BOURNS® Product Update Memo

March, 2006

Bourns® Trimpot® Division Announces Model 3224 Product Update

Tan Epoxy Compared to Traditional Blue Epoxy

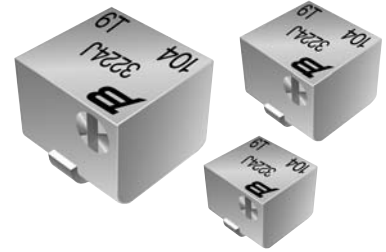
Bourns is pleased to announce a product update to the [Model 3224](#). Effective May 1, 2006 with date code 618M from Mexico (BdeM) and July 3, 2006 with date code 627C from Costa Rica (TEL), we will phase-in a new UV curable epoxy. The new epoxy is tan in color, meets all industry-processing guidelines and is environmentally friendly.
